Docket Number 50-346

Subject: Request for Nuclear Regulatory Commission (NRC) Approval
Pursuant to 10 CFR 50.54(a)(3)

- Attachment 2 Davis-Besse Unit 1 USAR 17.2, Quality Assurance Program
for Station Operation, Pages Affected By Proposed Change
- Attachment 3 Evaluation of Proposed Quality Assurance Program
Reductions

10CFR50.54 for UCN 95-006
Evaluation of Proposed Quality Assurance Program Reductions

Figure 17.2-1

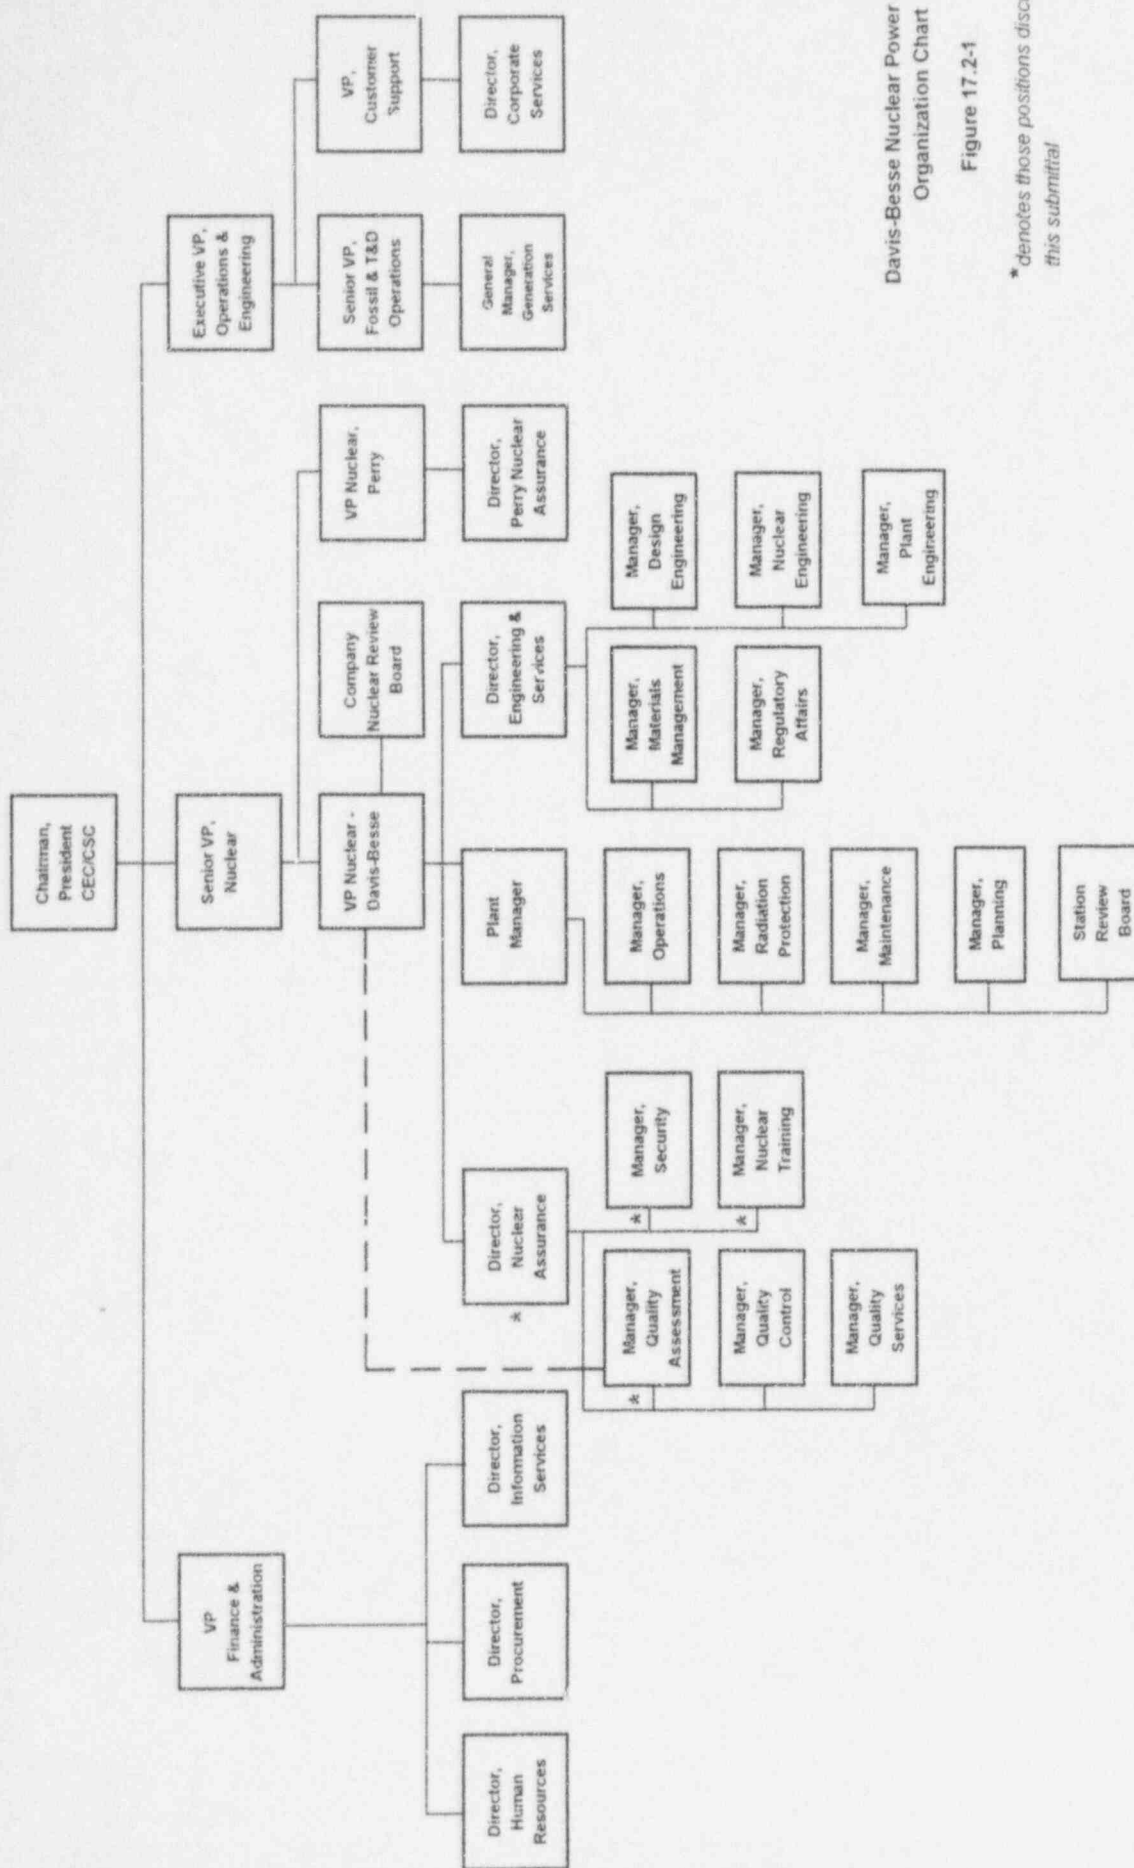
Davis-Besse Nuclear Power Station
 Organization Chart

* denotes those positions discussed in this submittal

The proposed changes to the Updated Safety Analysis Report (USAR) Chapter 17.2 are shown on the attached marked-up pages of Sections 17.2 Policy statement (page 17.2-2); 17.2.1.4 (pages 17.2-4, 17.2-5, 17.2-6, 17.2-7, 17.2-9, 17.2-10); 17.2.2.3 (page 17.2-13); 17.2.2.5 (page 17.2-15); 17.2.15.1 (page 17.2-42); 17.2.18.3 (page 17.2-48); 17.2.18.4 (page 17.2-49); 17.2.18.5 (page 17.2-49); and Figure 17.2-1.
